Subject ▶ Change on shear blade, internal gear, housing, etc.

For Models ▶ 4603D/DW(Battery-Powered Pruning Shear)

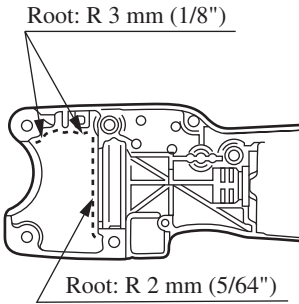
1.The screw pin will be changed in shape

CURRENT	NEW
<p>R 0.2 mm (0.008")</p>	<p>R 0.8 mm (0.032")</p>
